Technical Service Bulletin: tsb100249

Released Date: 12-Jan-2004

New Thermostat Housing Gaskets

New Thermostat Housing Gaskets

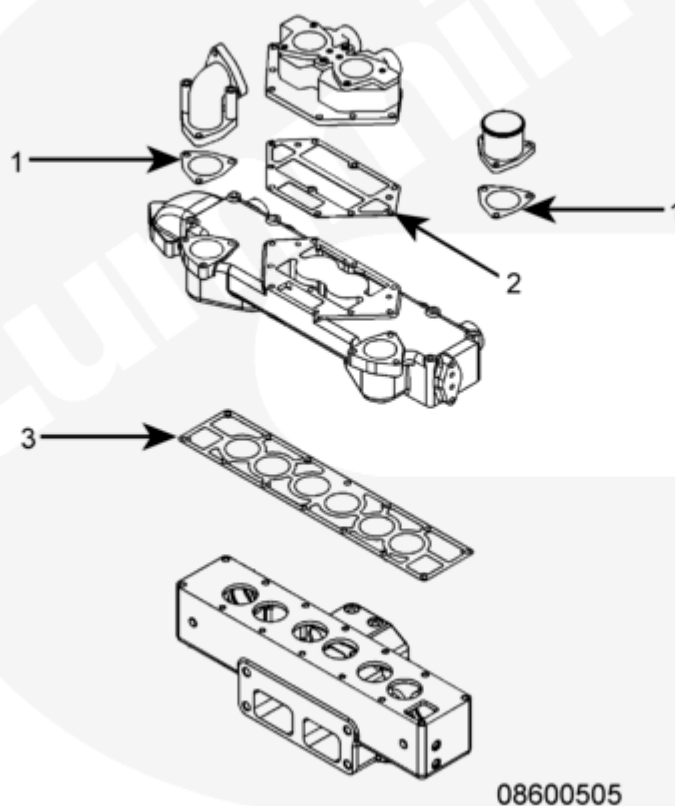
This Technical Service Bulletin introduces a new thermostat housing gasket on QSK45/60 engines. The new gasket is of a metal core construction which replaces the fibre type gasket. The new gaskets are designed to provide improved sealing, thus reducing premature leaks at these joints.

Item	Description	Old Part Number	New Part Number
1	Gasket, Connection	3089247	4101150
2	Gasket, Water Transfer Connection	3332081	4101149
3	Gasket, Thermostat Housing	3410688	4101148
